SUPPLEMENTAL INSTRUCTION

PROJ.: Meridian Community
Building Rebuild
PROJ. No.: 1841
DATE: Sept. 22, 2019
S.I. No. S.I. – A011

Additional Fireplace Section

SECTION AT FIREPLACE

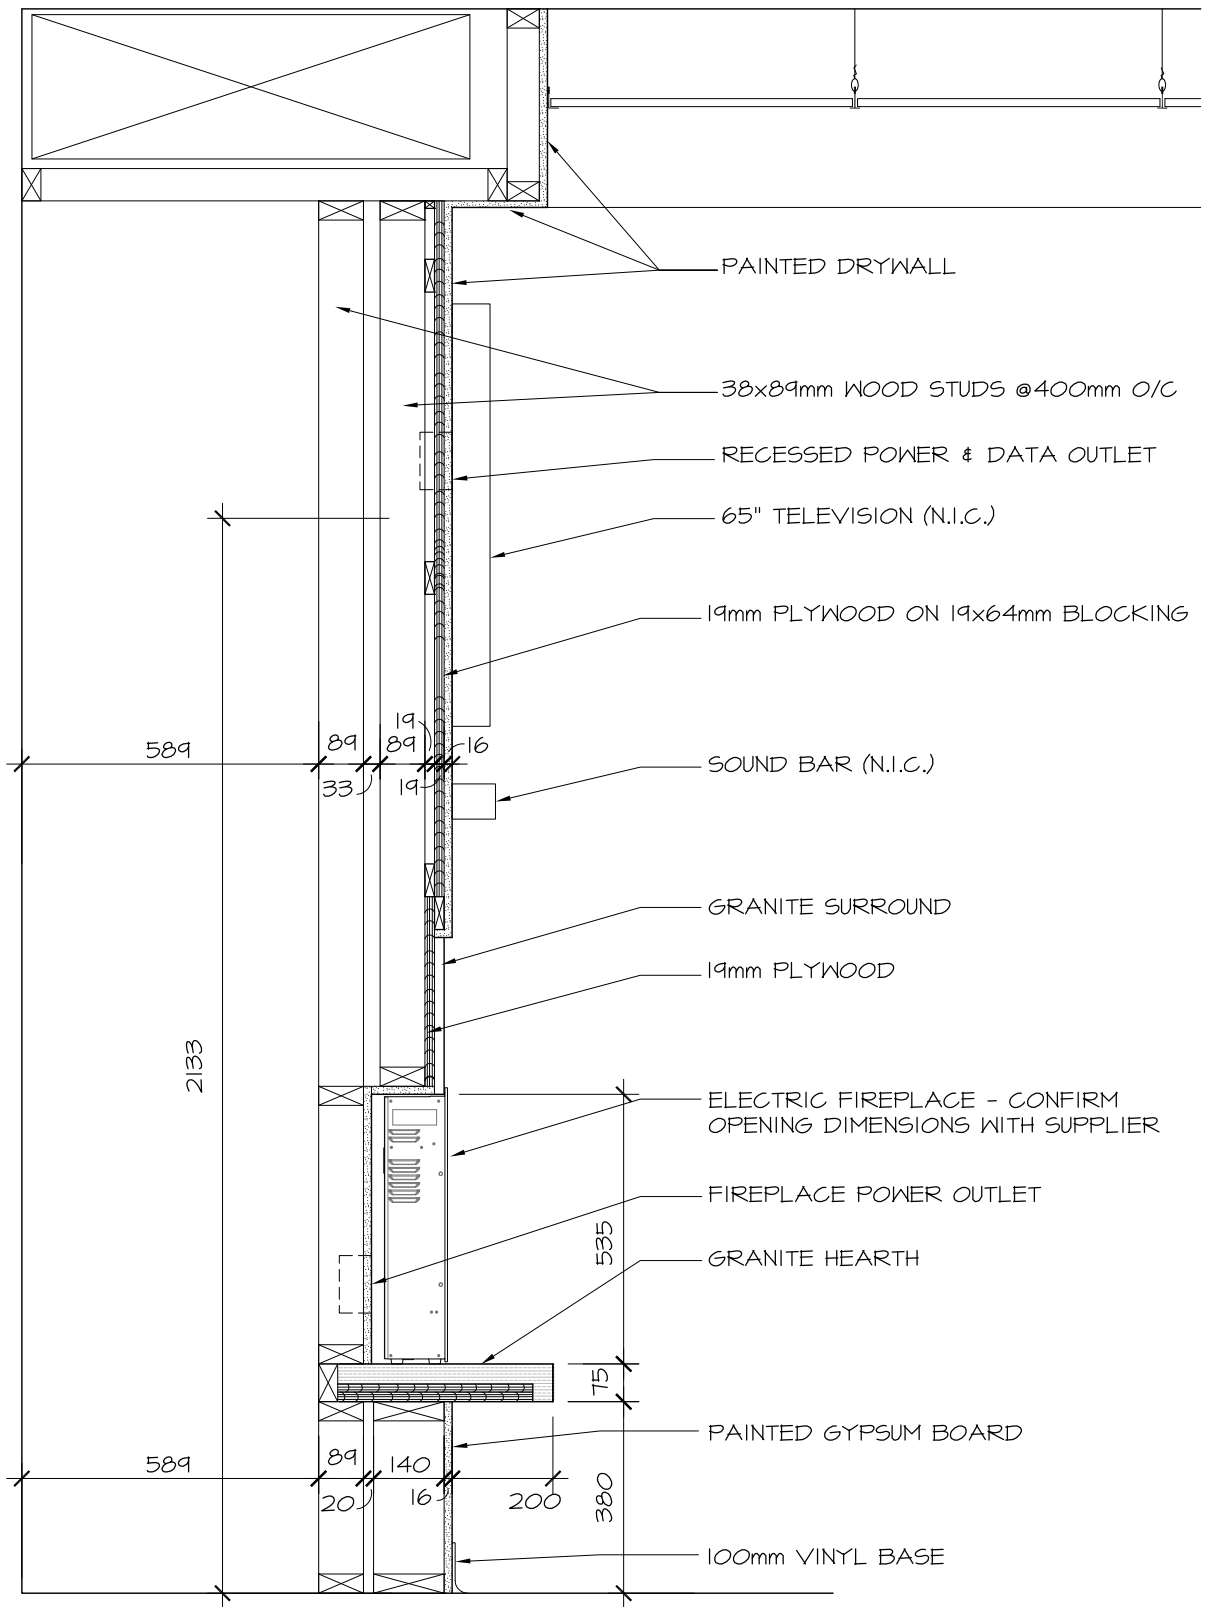
- .1 Refer to attached sketch 11/A8.02 for the section through the fireplace surround at the fireplace.
- .2 Plan detail 9/A8.02 has been revised to coordinate with the above noted section – see revised plan detail.
